**BIDS AND AWARDS COMMITTEE FOR INFRASTRUCTURE (BAC-I)**

**Bidding for the Construction of Various Structure and Facilities within the 100-hectare Area at Bataan Technology Park, Morong Bataan (Phase 1 Package 2)**

**BID BULLETIN NO. 4**

This Bid Bulletin clarifies additional queries sent through email, and other matters pertaining to the above Project.

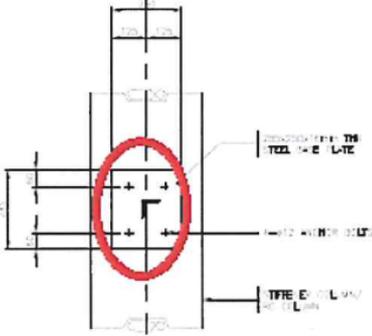
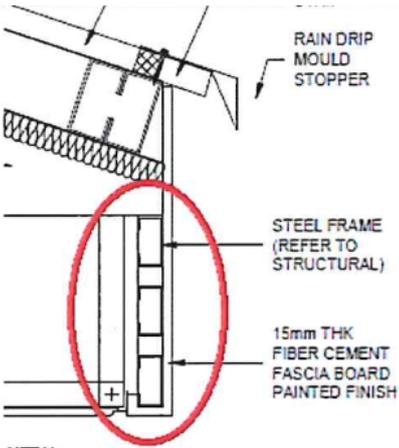
Q10. Please provide information/details, photo, plan, and location for the following items below: a. Underwater Egress Pool (required dimension/area, depth, and etc.) b. Jumping Platform, including Stair (required height, etc.) c. Zip Line (required length, height, etc.) d. Steel Beam including RC Post (required height, length, and etc.) e. In-Ground Viewing Area (required dimension, and etc) f. Overhead Catwalk (required width, length, and etc.)	Please refer to the link below for the minimum specifications for items under "OTHERS FOR SWIMMING POOL" in the Bill of Quantities and Detailed Cost Estimate Form: <a href="#">Swimming Pool Minimum Specs</a>
<b><u>STRUCTURAL WORKS</u></b>	
Q11. <b>BUILDING NO. 3</b> Provide purlin connector details for purlins to steel girders	Please refer to Drawing Sheet ST-6 provided in the link below: <a href="#">Standard Drawings (Structural)</a>

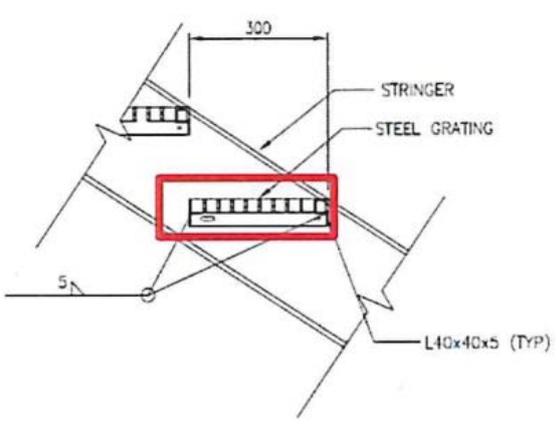
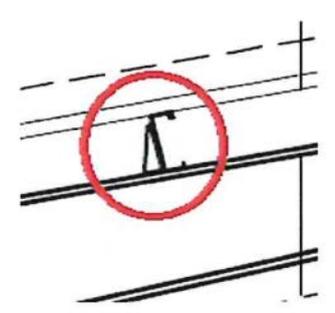
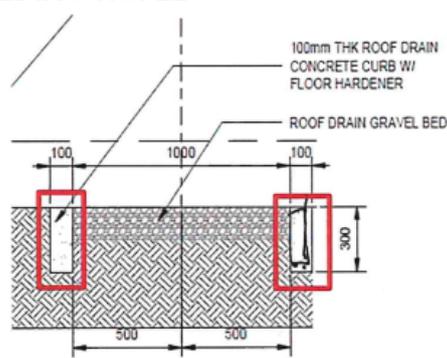
<p>b. Please provide details of lintel beam</p> <p>beam</p>	<p>5-12 mm longitudinal bar and 10dia ties @ 150 mm o.c. as shown</p>
<p>c. Please provide rebar details of zocalo</p>	<p>S1-150 mm thk, 12 mm dia @ 150 mm main bar shown and 12 mm dia longitudinal bar @ 200 mm o.c.</p> <p>12 mm dia @ 400mm vertical bar shown and 12 mm dia longitudinal.</p>
<p>d. Please provide details of the concrete path walk and concrete curb</p>	<p>Please refer to Drawing No. A78-20 detail No. 5, as provided in the link below, for the typical concrete curb detail: <a href="#">BLDG-78-A78-20.png</a></p>

**Q18. BUILDING NO. 25**

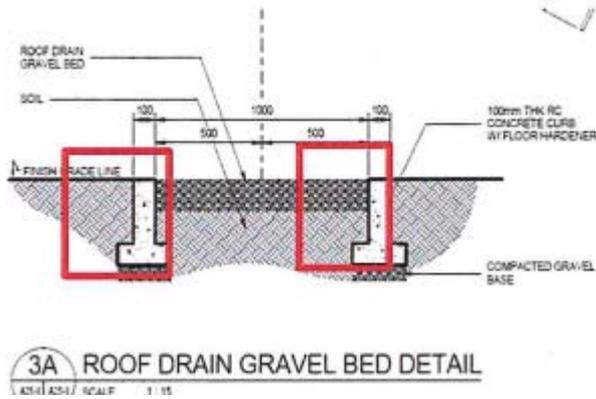
Please provide rebar details for the concrete curb

Please refer to the response to Q14.d.

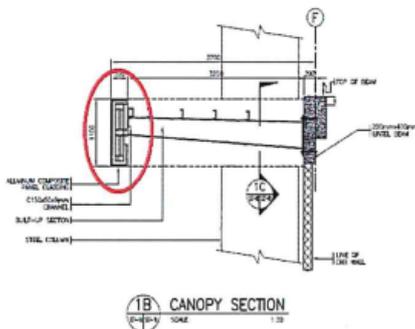
- a. Provide steel connection details that will support the aluminum composite panel cladding

Cladding is to be supported by the steel rafter. Please refer to Drawing Sheet No. A-27-28 Detail No. 1D, provided in the link below:  
[BLDG-27-A27-28.pdf](#)

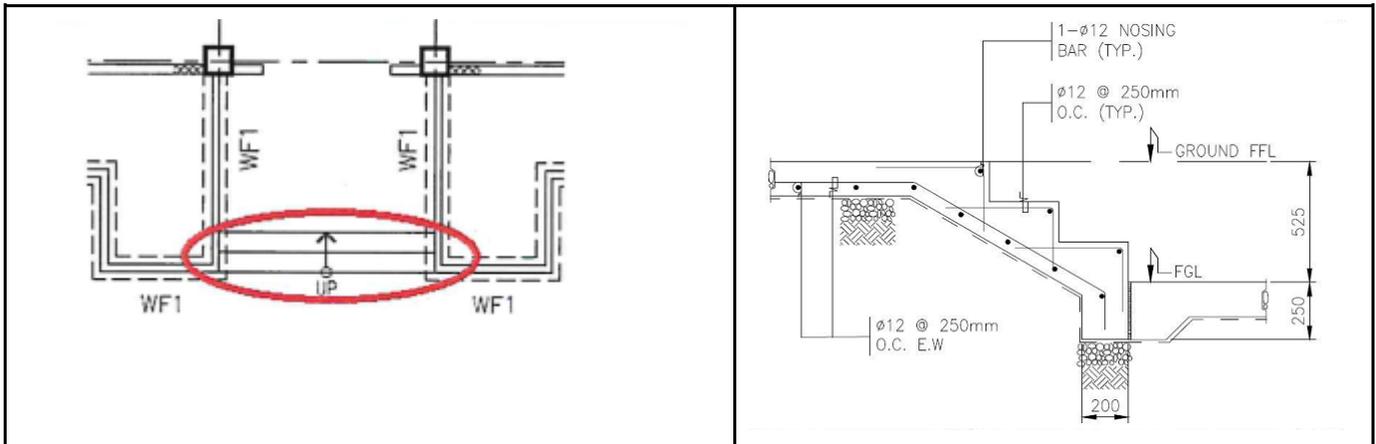
- c. Provide structural details for stair in grid line F/6-7

Please refer to the structural details below.

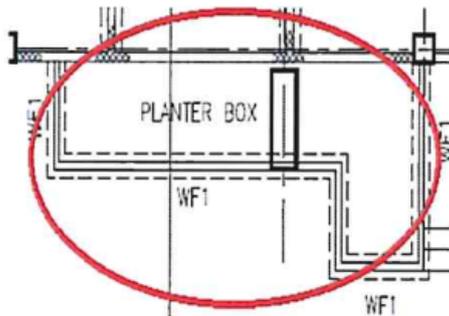
d. If the walls of the planters are not CHB, please provide RC wall details

Please follow the architectural drawings for the planter box.

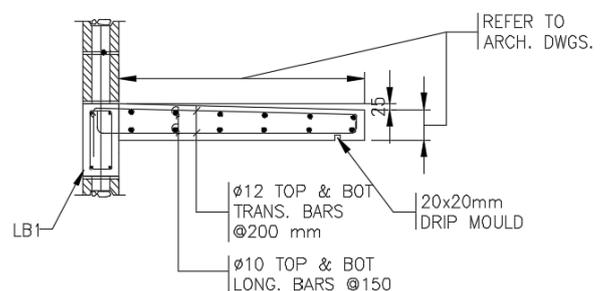
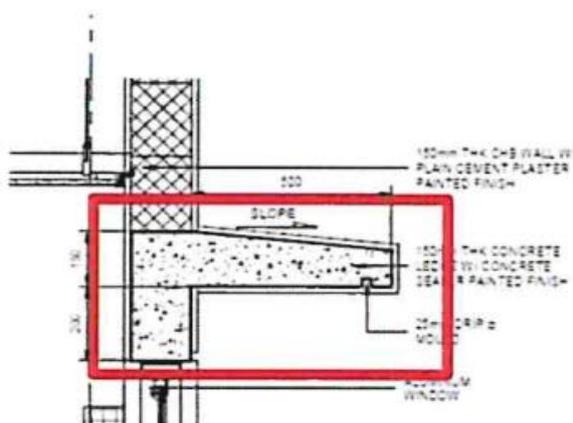
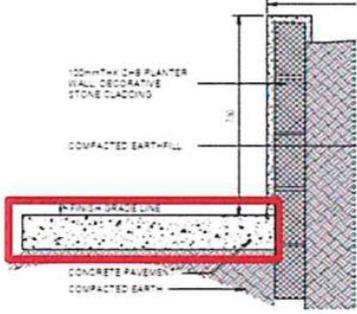
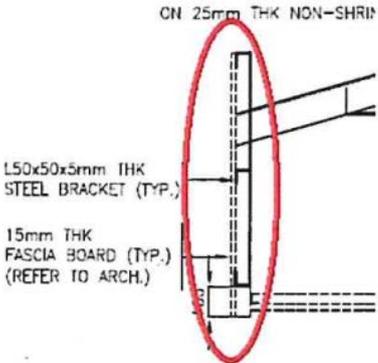
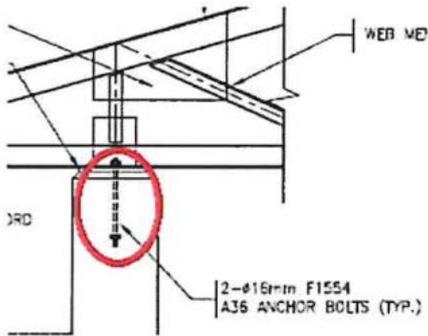
b. Please provide rebar details of the concrete canopy, refer to drawings below:

Please refer to the rebar details below:

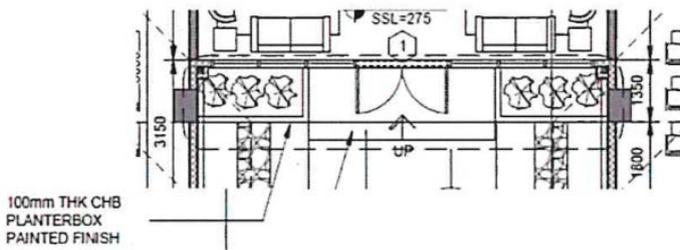
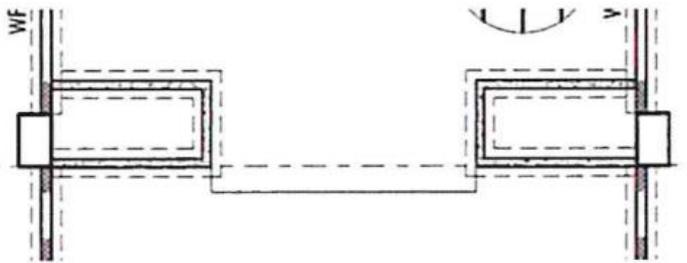
- a. Please confirm if the planter box as shown below is an RC wall or CHB wall. As per the architectural plan, it is CHB while as per the structural plan, it is RC. If RC, please provide rebar details.

Please use CHB for the planter box as per architectural detail Section 1C A78-16.

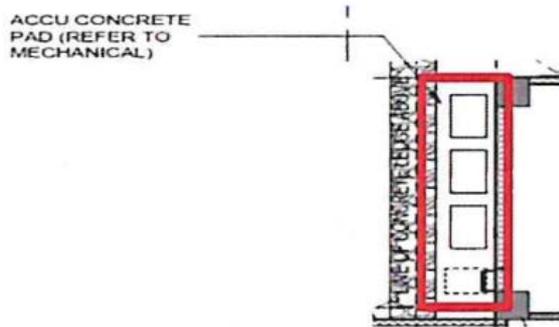
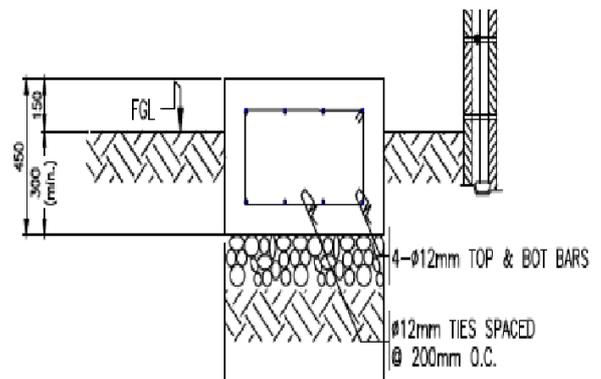
- b. Please provide rebar details and thickness of ACCU pad for mechanical

Please refer to the rebar details below:

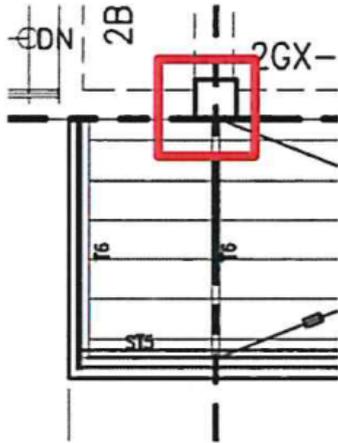
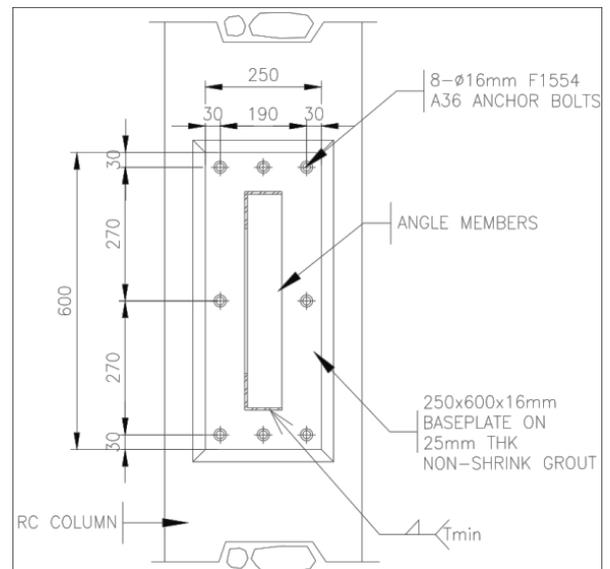
a. Please provide connection details of T6 to RC Column/Beam

Please refer to the connection details below:

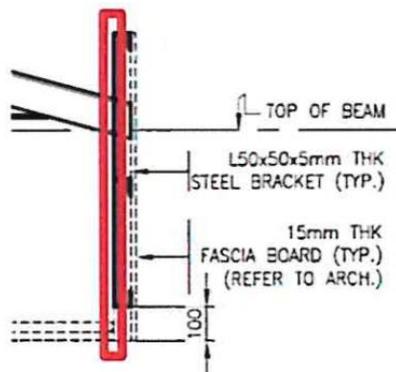
b. Please provide steel member section details and spacing, see highlight in red.

The steel bracket is fully welded to the truss end. Bracket assembly includes 3 horizontal members, as shown, and a vertical member at every 300mm, all by L50x50x5mm.

Please refer to Drawing Sheet No. A-84-23 Detail No. 2C, as provided in the link below:

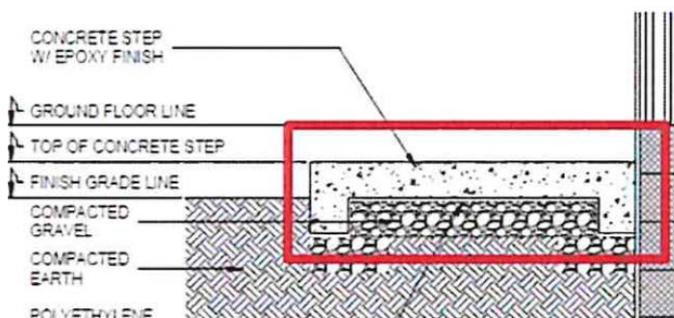
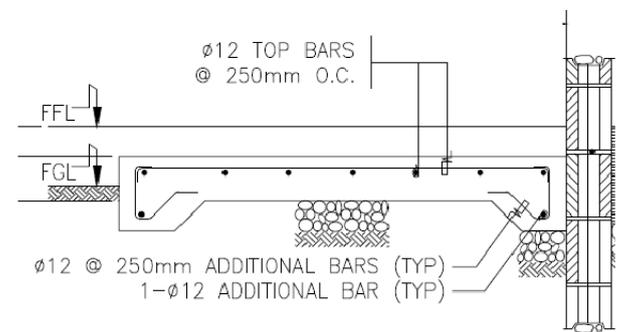
c. Please provide rebar details of concrete steps

Please refer to the rebar details below:

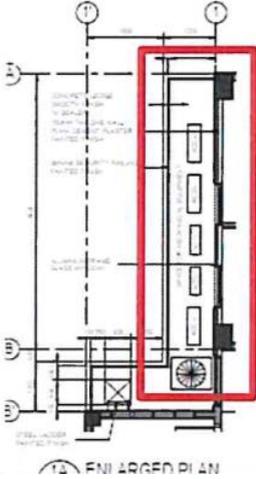
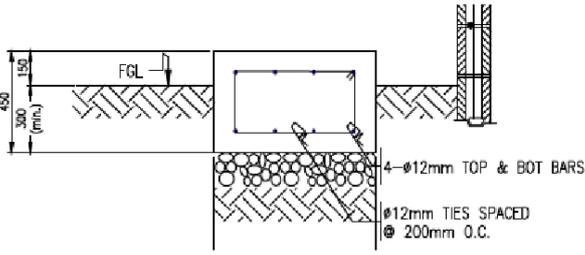
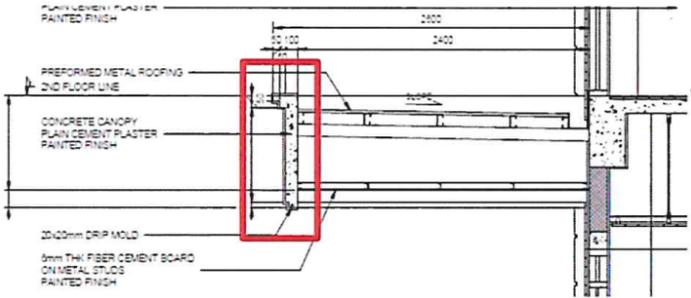
d. Please provide ACCU details and thickness of ACCU pad for mechanical

Please refer to the detailed drawing below:
